## *City of El Paso – City Plan Commission Staff Report*

**Case No:** SUSU12-00092 Ventanas Subdivision Unit Six  
**Application Type:** Major Final  
**CPC Hearing Date:** October 18, 2012  
**Staff Planner:** Justin Bass, 915-541-4930, [bassjd@elpasotexas.gov](mailto:bassjd@elpasotexas.gov)

## ATTACHMENT 4

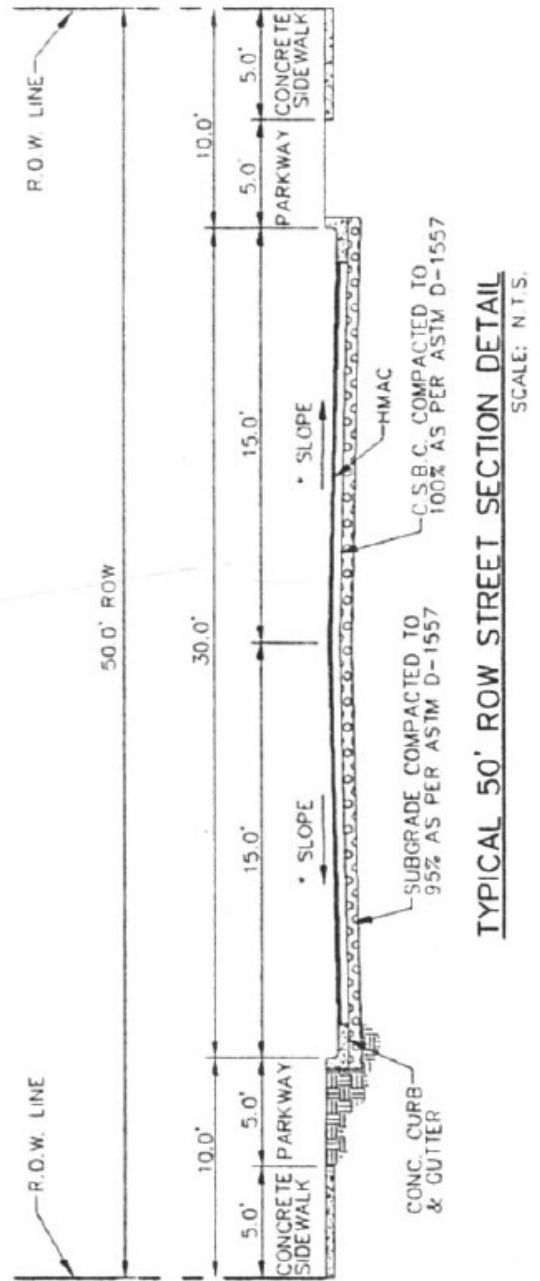
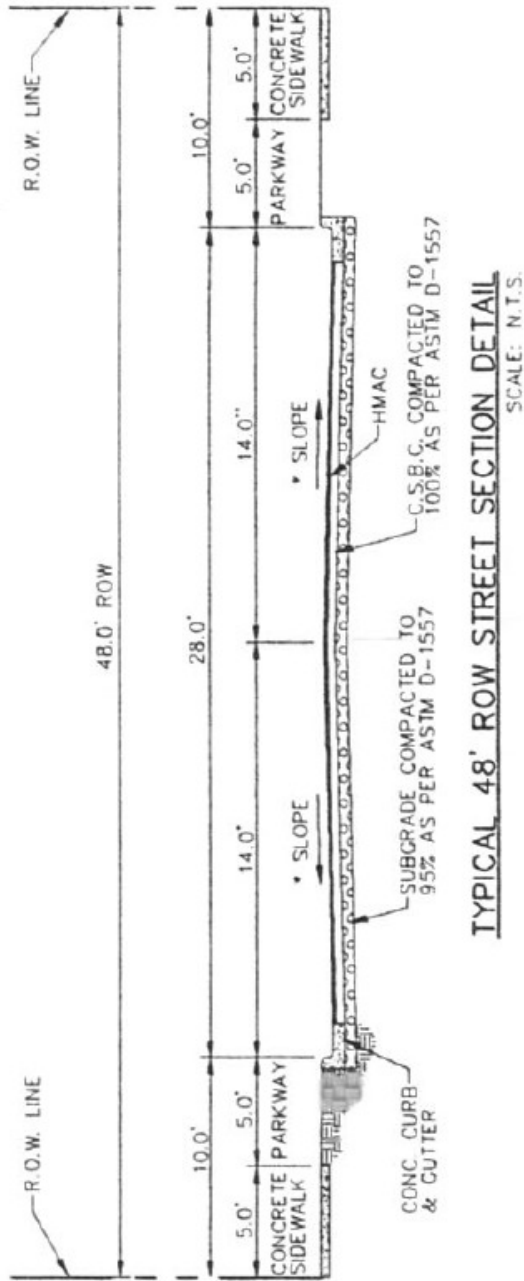
- To allow for the reduction of street right-of-way from 52-ft to 50-ft. The cross-section

will consist of 5-ft sidewalks, 5-ft parkways, and 30-ft of pavement, with a standard concrete curb and gutter.

- To allow for the reduction of street right-of-way from 52-ft to 48-ft. The cross-section will consist of 5-ft sidewalks, 5-ft parkways, and 28-ft of pavement, with a standard concrete curb and gutter.
- To allow for a street name longer than 13 characters.

The Development Coordinating Committee recommends ***approval*** of the modifications under Reason 3 of Section 19.04.170.A of the previous Subdivision Ordinance and ***approval*** of Ventanas Subdivision Unit Six on a **Major Final** basis subject to the following conditions and requirements:
